Tuesday, March 26, 2013 1:37:57 PM Item ID: 646,9701 Accept \*N900040100\* Setup Start **Revision ID:** Item Name: Cutter Sub Assembly **Start Date:** 3/26/2013 Start Qty: 4.00 Cust Item ID: Required Date: 3/28/2013 Reg'd Oty: 4.00 **Customer:** Reference: Run Start Process Plan: Date: 13.3. Tooling: Approvals: Date: Stop QC: Date: SPC (Y/N): Date: Sequence ID/ Operation Set Up/ Tool ID Tool # Plan Accept Reject Reject Work Center ID Description **Run Hours** Code Qty Qty Number Draw Nbr **Revision Nbr** 646.9700 N/C 110 Pick Kit 0.00 \*110\* Packaging 0.00 Memo Packaging 120 0.00 \*120\* Small Fab 0.00 Memo Small Fab Assemble as per dwg and apply loctite 598 on all mating surfaces per note 2. 13-03-264 \$ A/R LOCTITE 598:

Item Name: Cutter Sub Assembly

T		·····		***************************************		<u> </u>	· · · · · · · · · · · · · · · · · · ·			***************************************	
	ENGIN	EERING	CHANGE	E NOTICL	_ NO.		2744		SHE	ET 1	- □F	1
APICAL	DWG 1	VD. 64	6,9700	REV:N/C	PREPARE BY	S.HL	FF	DATE:	01/07/10		ECT ON NC. 🖾 U	
INDUSTRIES, INC	.DWG			CUT	TER	SUB A	\$5Y					
	APPROVED	BY: ENGR	3000	MEG	19	23.7	QC //	mille	Fran EFFI	NEXT [	JRDER	
TRANSACTION CODES (TC): A-ADD

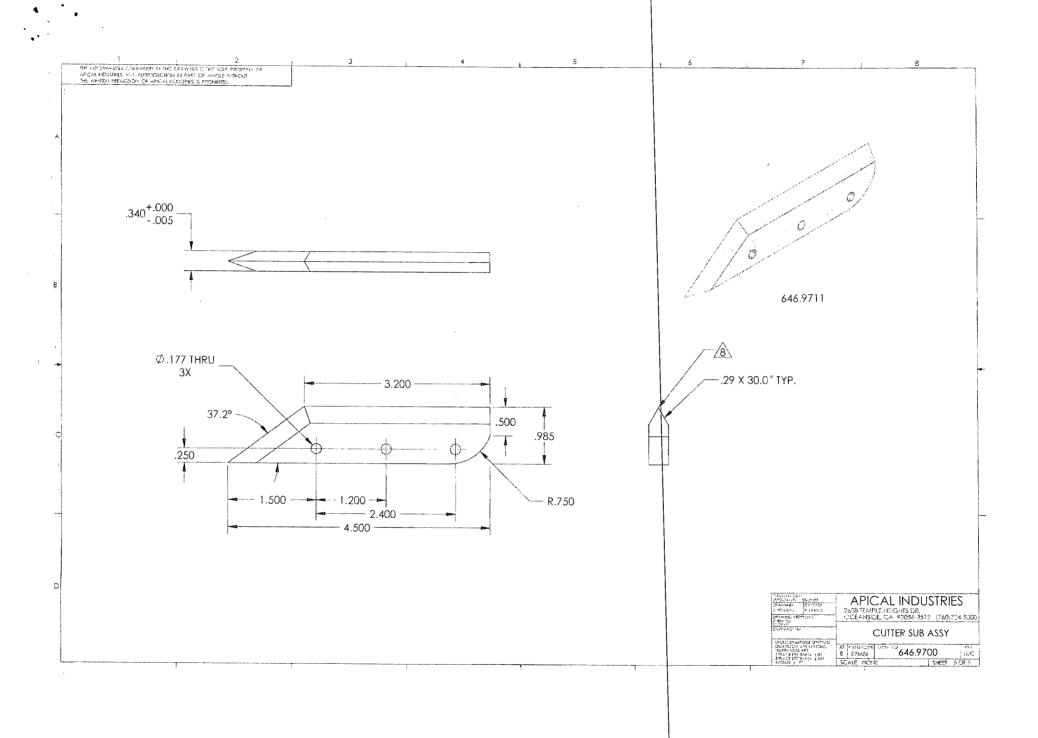
SHEET 2, ZONE C	6, IS		<u>S</u> ł	HEET 5, ZON	NE C2,	IS:			<u></u>			
352 <sup>±</sup> .005	2° ZPL	A 384	9 177 3x -250 -1			1.200		R 750		(600°)	30.0° TYP.	
		3 X 450° TYP.—	SECTION B-B	ر								
3 R 601.3157	12	SCREW					MS2	7039-0818				
	.9701				-							
F/N TC PART NUMBER	QTY	DESCRIF	TION						/SPECIFICA	TION		
DOCUMENTS EFFECTED:		☐ INSTAL	L INSTRUC	⊠ ICA □	FMS 🛛	BOM O MA	GE CAT	EGORY 1 MINOR	DER REVIEW  U YES	REQUIR ⊠ N□	ED
